4.1 Lot 622 (No.2) Aurea Boulevard, Golden Bay - Proposed mixed commercial development (Golden Bay Neighbourhood Centre) – DAP/24/02447

**Part B – Item 4.1 - LOT 622 (No.2) AUREA BOULEVARD,
GOLDEN BAY – REQUEST TO AMEND DEVELOPMENT
APPROVAL (GOLDEN BAY NEIGHBOURHOOD CENTRE) –
AMEND LIQUOR STORE TO MOTOR VEHICLE WASH**

**Form 2 – Responsible Authority Report
(Regulation 17)**

Figure 1. Approved GBNC development layout

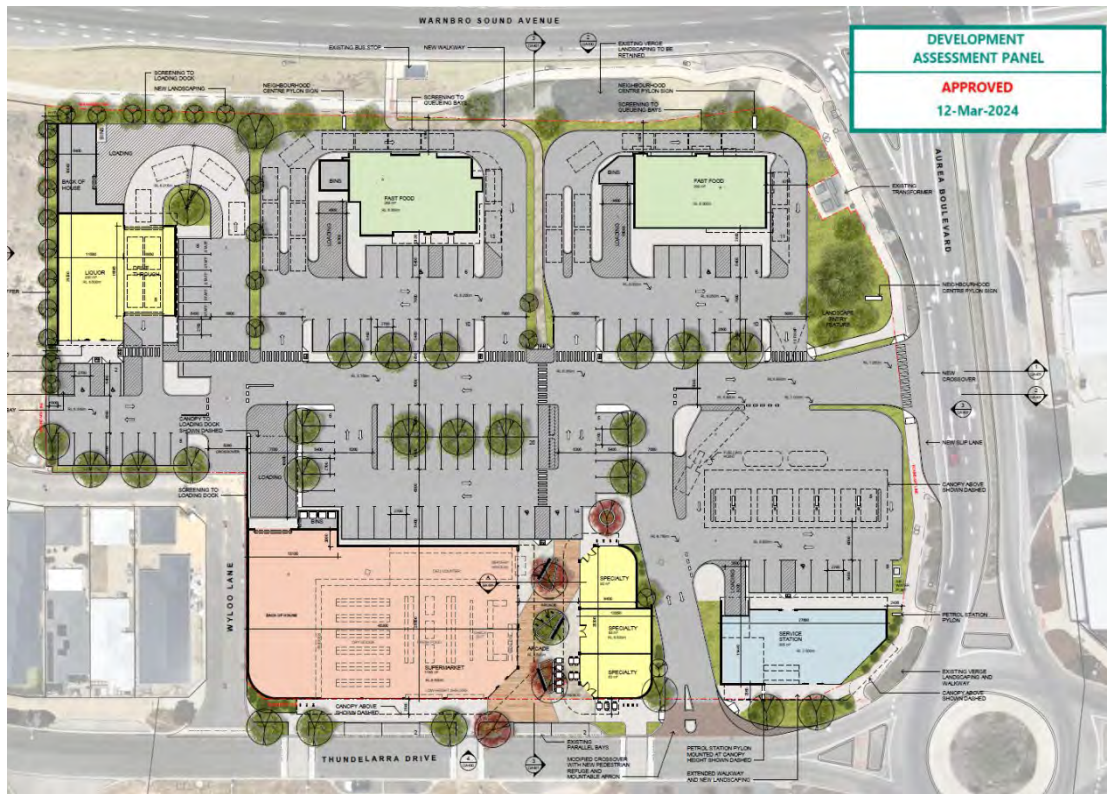
The following images show the approved GBNC development layout and the proposed change (refer RAR Attachment 3 for further detail).

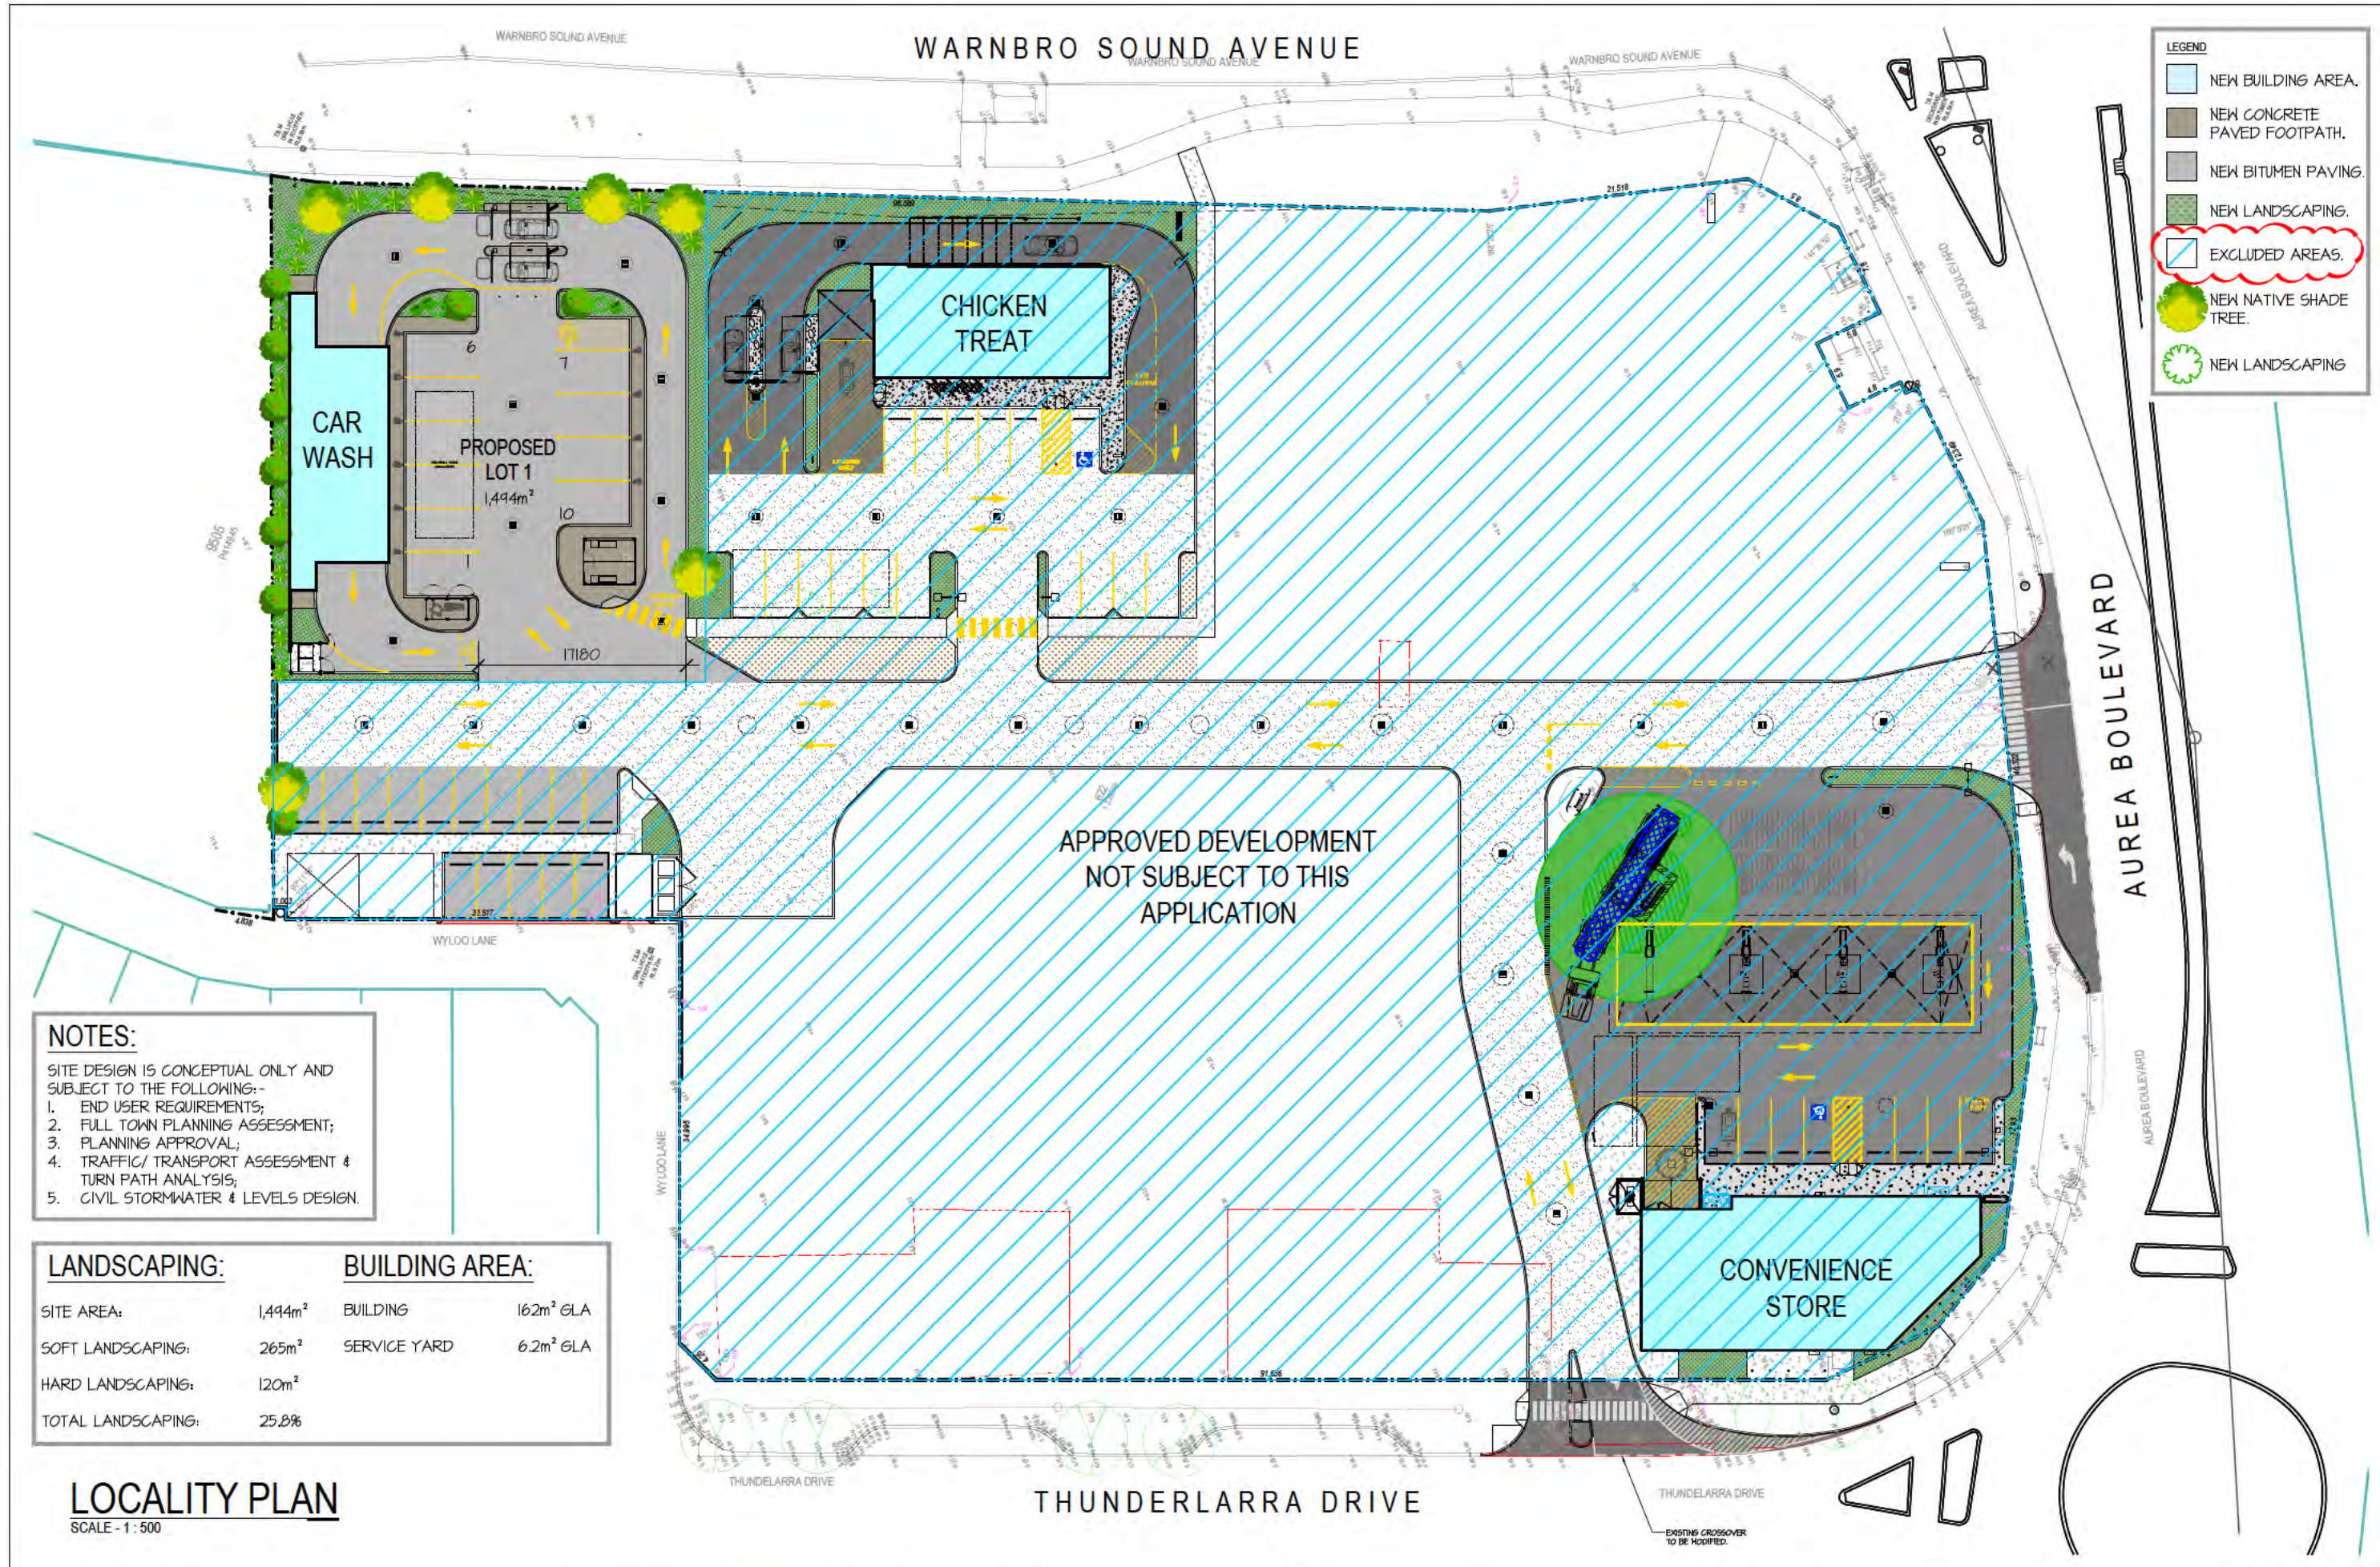
The submitted ENA has considered noise emissions from the proposed development to surrounding properties by way of noise modelling of mechanical plant, automatic wash bays, vehicles and vacuum units. A number of recommendations from the ENA including installation of an acoustic wall and rollers doors on the automatic wash bay, have been presented to mitigate noise to achieve compliance with the EPNR. These mitigation measures are recommended to be imposed as a separate and specific conditions to ensure they are implemented in the design and operational phases of the development. Figure 6 depicts the Motor Vehicle Wash facility in context of the northern allotment and the acoustic wall extent, and Figure 7, extracted from Attachment 1, shows the proposed elevation.

2. The Motor Vehicle Wash development must comply with the requirements and recommendations of the Lloyd George Acoustics report dated 27 June 2025 (ref. 24119644-01A) and shall incorporate:

- (i) A five metre high solid screening wall to the west end of car wash building, as shown on the approved plans;
 - (ii) Vacuum centrifugal system with no more than 90 dB(A) sound power level and with full perimeter fencing of 1.8m in height and 8kg/m² surface mass or greater that seals at ground. Exhaust flue must not protrude beyond the fence height;
